# Technical Service Bulletin

## 20 Fuel line noises between 1000-2000 rpm

20 20 32 2061778/1 December 18, 2020.

Model(s)	Year	VIN Range	Vehicle-Specific Equipment
TT	2019 - 2021	All	2.0TFSI

*Figure 1. Lines in the tank.*

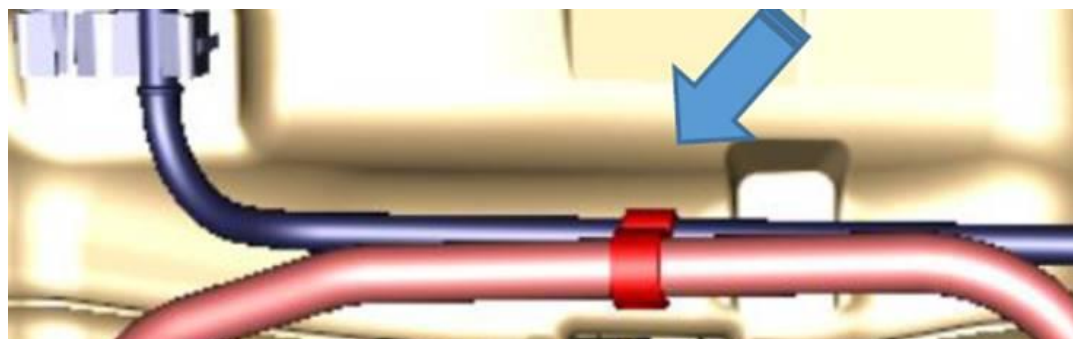
- The rattling noise from the fuel lines can be duplicated.
- The fuel supply line (between fuel pump and connector in the area of the inner sill) is detached at the fuel tank.

The TT fuel supply lines can vibrate against the fuel tank in certain cases. This phenomenon occurs when the two fuel lines begin to resonate between 1000-2000 engine rpm and rattle against one another or the tank.

Apply the clip WHT 007 935 and apply it centrally between the two fuel lines (Figures 1- 2).

Make sure there is now sufficient spacing between the fuel lines.
